# National Committee on Uniform Traffic Control Devices

Recommended Changes to Proposed Text for 11<sup>th</sup> Edition of the MUTCD

Docket Number: FHWA-2020-0001

NPA MUTCD Section Number: Sections 3D.01-3D.07

Figure 3D-1. Example of Markings for Approach and Circulatory Roadways at a Roundabout

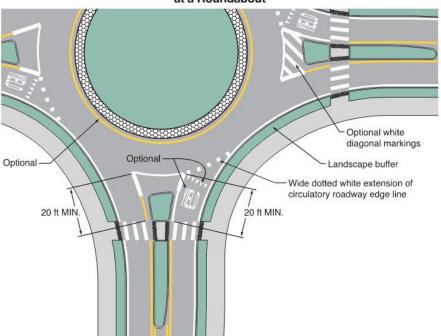
> A yellow edge line may be placed around the inner (left-hand) edge of the circulatory roadway (see Figure 3D-1) and may be used to channelize traffic (see Drawing B of Figure 3D-

> Wide dotted white edge line may be 18 to 24 inches wide and 2-3 feet line with 2 feet gap. [add Option]

Figure 3D-2. Example of Markings for a One-Lane Circular Intersection

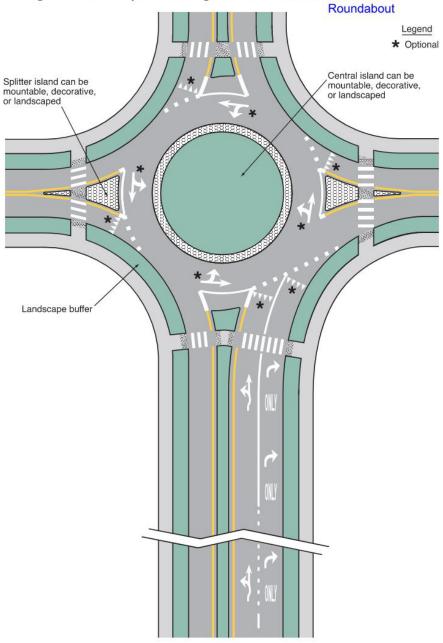
> Section 3D.04 Comments: NCUTCD generally agrees with 3D.04 as presented in the NPA, but recommends removing the Standard statement requiring yield lines at roundabout entries, as research has not shown the yield lines as effective for multilane roundabouts. NCUTCD recommends revising the Option statement to allow yield lines at all roundabouts, and add references to appropriate figures.

A yield line (see Section 3B.19) shall be used at multilane roundabout entries to indicate the point in each entry lane behind which vehicles are required to yield to all circulating lanes at the entrance to a roundabout (see Figure 3D-2). [remove Standard]

A yield line (see Section 3B.19) may be used at single lane roundabout entries to indicate the point behind which vehicles are required to yield at the entrance to a roundabout (see Figures 3D-1 and 3D-2). [revise Option]

Figure 3D-6. Example of Markings for a Two-Lane Circular Intersection with a Dual Left Turn Roundabout

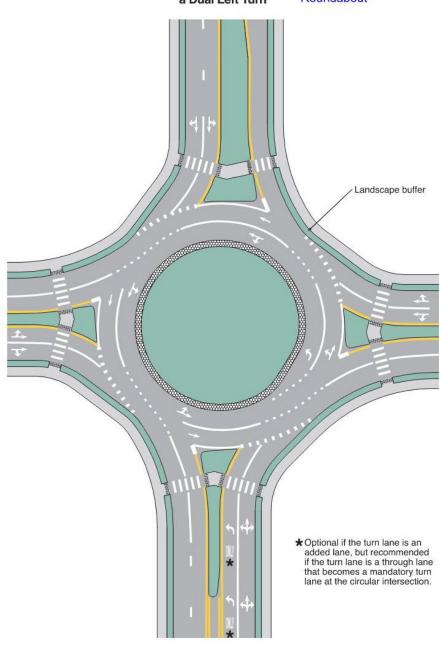
Lane-use arrows should be used on approaches to circular intersections with dual left or dual right turns.

Figure 3D-8. Example of Markings for a Diamond Interchange Using Two Gircular Intersections

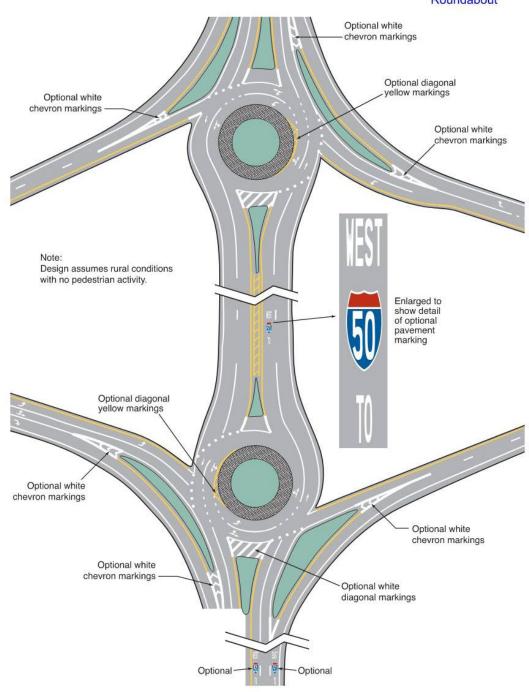
Word and/or route shield pavement markings may be used on an approach to or within the circulatory roadway of a roundabout to provide route and/or destination guidance information to road users (see Figure 3D-8).
